AMENDMENT OF SOLICITATION

1. AMENDMENT/MODIFICATION NO. 0002	2. EFFECTIVE DATE JUL 03, 2003															
3. ISSUED BY DEPARTMENT OF THE ARMY, BALTIMORE DISTRICT CORPS OF ENGINEERS P.O. BOX 1715 BALTIMORE, MARYLAND 21203-1715 CODE: _____

6. ACCOUNTING AND APPROPRIATION DATA (If required) MAINTENANCE DREDGING, HONGA RIVER AND TAR BAY, BACK CREEK AND TYLER COVE, DORCHESTER COUNTY, MARYLAND.

TYPICAL BREAKWATER SECTION

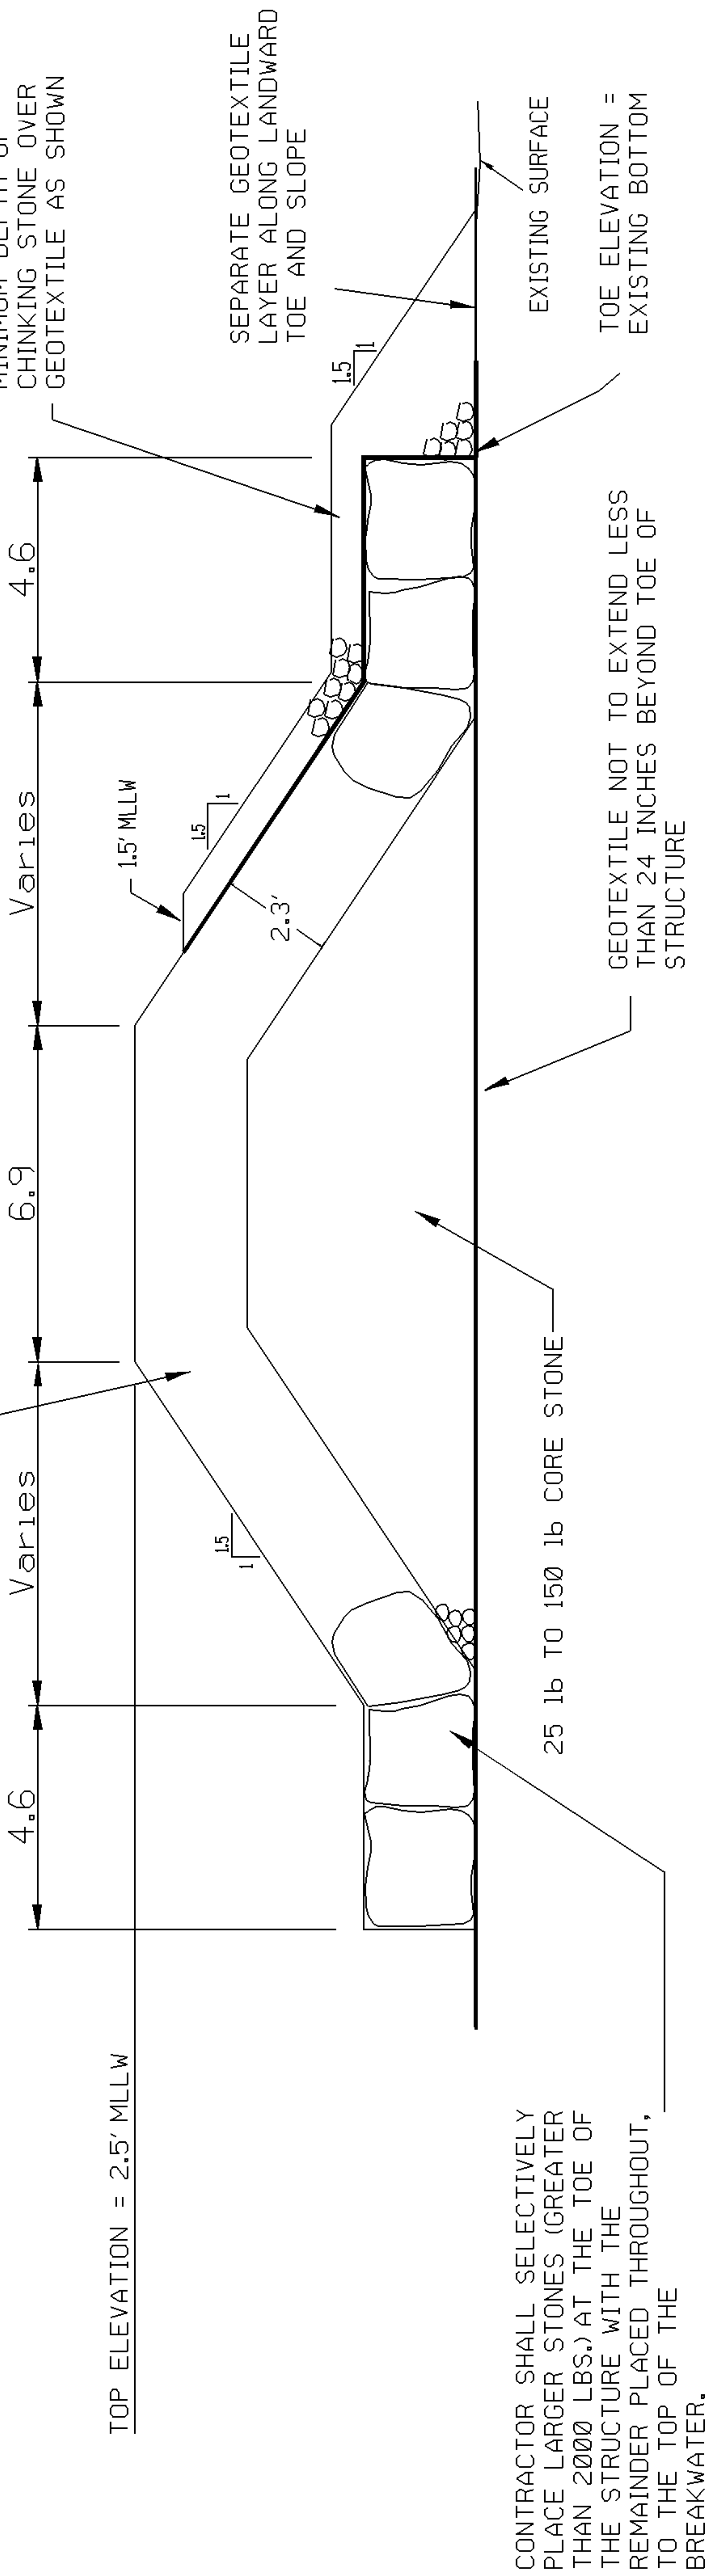
(2) Sheet 12 of 13, Typical Breakwater Section: Delete this cross-section, as originally issued, and substitute therefor the attached revised cross section SK-1.

1300 LB TO 3000 LB ARMOR STONE TO BE SELECTIVELY CHOSEN AND PLACED TO PROVIDE A RELATIVELY FLAT OUTER SURFACE. PLACEMENT SHALL BE SUCH THAT STONES TIGHTLY ABUT AND LEAVE MINIMUM SPACE BETWEEN STONES.

CHINK LANDWARD SIDE OF STRUCTURE WITH 25 LB. TO 150 LB. STONE PRIOR TO PLACEMENT OF SEPARATE LAYER OF GEOTEXTILE WHICH SHALL NOT EXTEND LESS THAN 6 FT. LANDWARD OF THE TOE OF THE STRUCTURE. PLACE 8 INCH MINIMUM DEPTH OF CHINKING STONE OVER GEOTEXTILE AS SHOWN

TYPICAL FLUSHING PORT SECTION

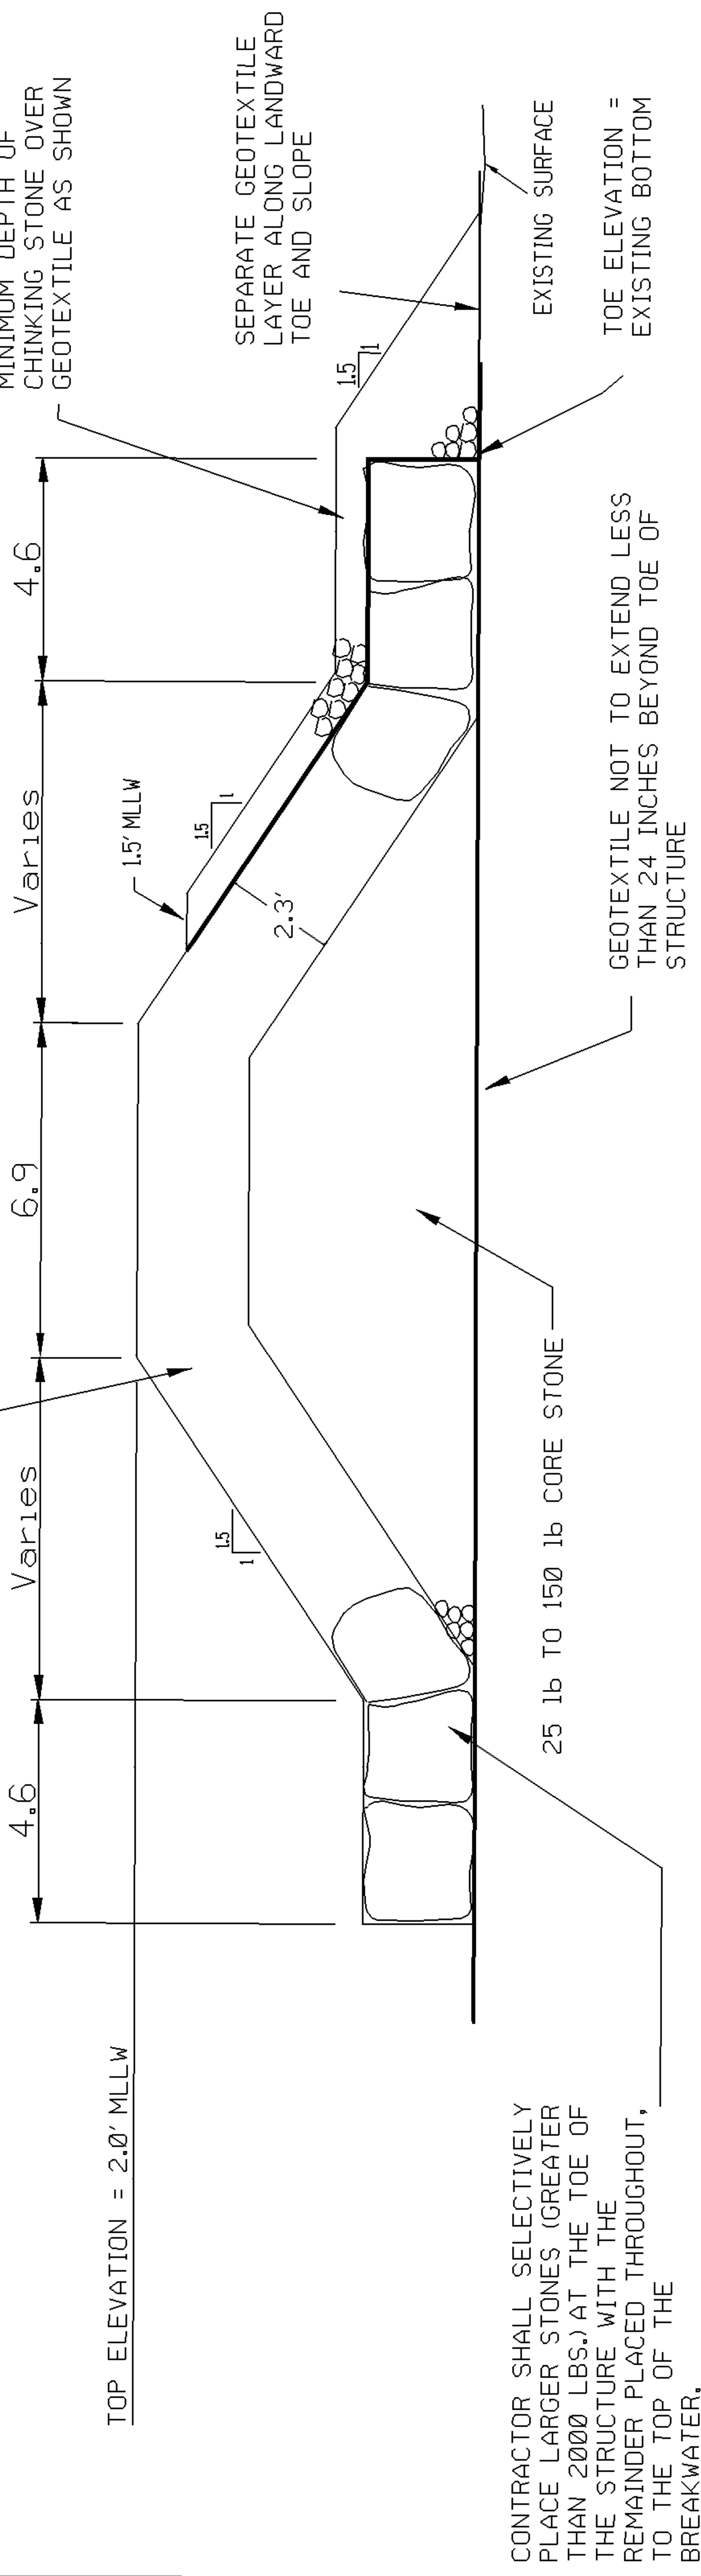
(3) Sheet 13 of 13, Typical Flushing Port Section: Delete this cross-section, as originally issued, and substitute therefor the attached revised cross section SK-2.

1300 LB TO 3000 LB ARMOR STONE TO BE SELECTIVELY CHOSEN AND PLACED TO PROVIDE A RELATIVELY FLAT OUTER SURFACE. PLACEMENT SHALL BE SUCH THAT STONES TIGHTLY ABUT AND LEAVE MINIMUM SPACE BETWEEN STONES.

CHINK LANDWARD SIDE OF STRUCTURE WITH 25 LB. TO 150 LB. STONE PRIOR TO PLACEMENT OF SEPARATE LAYER OF GEOTEXTILE WHICH SHALL NOT EXTEND LESS THAN 6 FT. LANDWARD OF THE TOE OF THE STRUCTURE. PLACE 8 INCH MINIMUM DEPTH OF CHINKING STONE OVER GEOTEXTILE AS SHOWN

CONTRACTOR SHALL SELECTIVELY PLACE LARGER STONES (GREATER THAN 2000 LBS.) AT THE TOE OF THE STRUCTURE WITH THE REMAINDER PLACED THROUGHOUT, TO THE TOP OF THE BREAKWATER.
